# SERVICE INFORMATION LETTER

KX 200 Slide-In Replacement Clarification.

Figure 2. KX 155 Wiring Interconnect

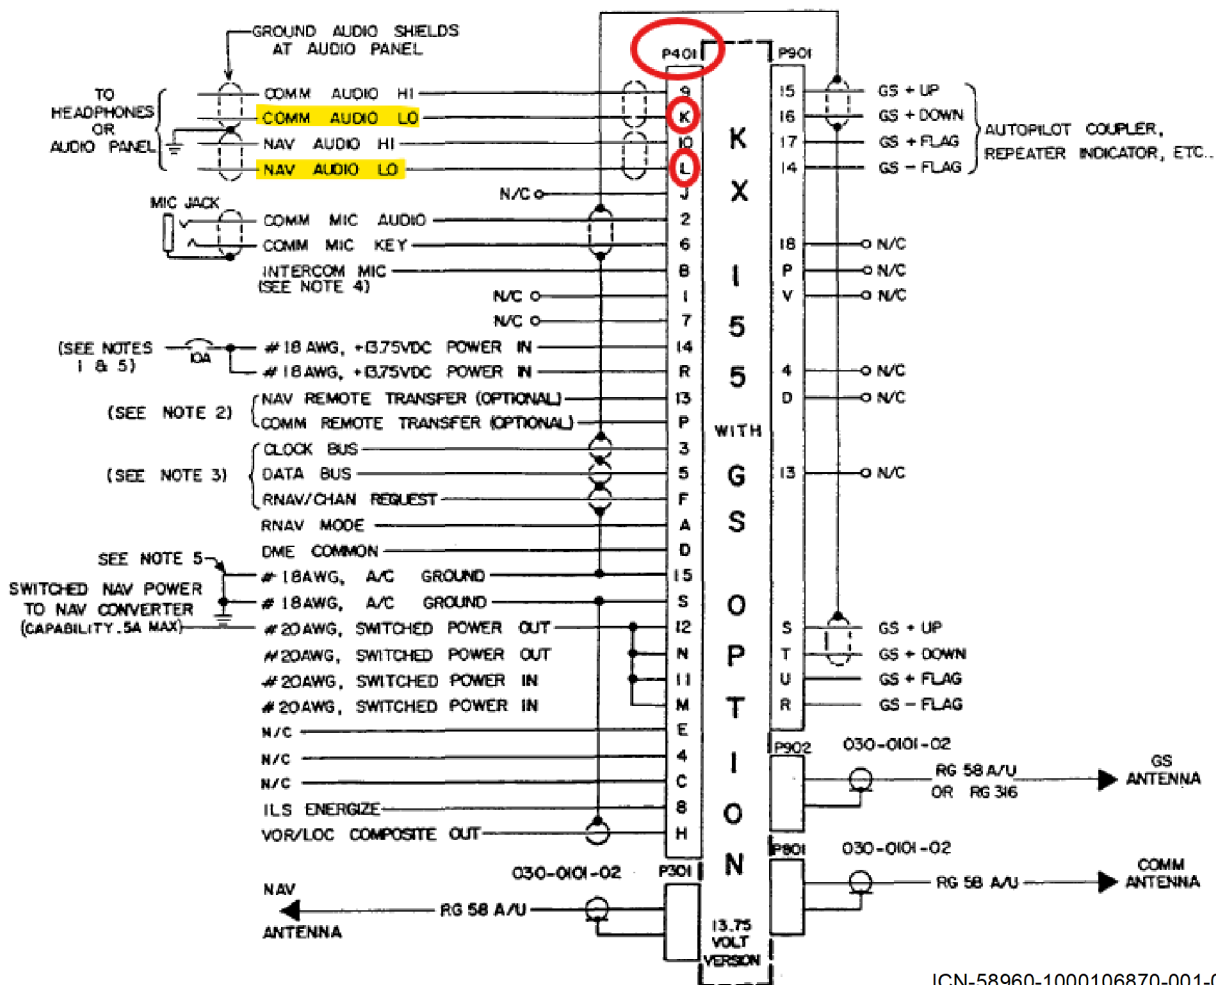
- (a) BendixKing legacy audio panels - KMA 20 and KMA 24 - were built to be used with the legacy KX 170/175B Nav/Com Radios. If the KX 170/175B was removed and replaced by the KX-155 using the same KMA 20 or KMA 24 audio panels, two (2) ground wires may be required to be installed on pin K Com Lo and pin L, Nav Audio Lo on the KX 155 connector P401.
- (b) A visual inspection of pins installed in P401, pin K and pin L, on the KX 155 rear connector plate can assist in determining if pins are already installed. Refer to [Figure 1](#).
- (c) The KX 155 interconnect drawing is also included for illustration purposes. This specific example is from a KX 155 with glideslope option but pins K and L are on P401 in all versions of the KX 155. Refer to [Figure 2](#).

- (a) Reference your aircraft's logbooks and determine if a legacy KX 170/175B was previously installed with a KMA 20 or KMA 24 audio panel, and the KX 170/175B was eventually replaced with a KX 155 Nav/Com radio.
- (b) If not, no action is required and the KX 200 slide in replacement Nav/Com radio is expected to work as advertised.
- (c) If yes, then two (2) ground wires will be required to be installed on pin K Com Lo and pin L, Nav Audio Lo on the KX 155 connector P401.
- (d) If extra pins are needed, refer to [Paragraph E.\(2\)](#) in this SIL for additional information.
- (e) A sample drawing of the pin below is provided for reference. Refer to [Figure 3](#).
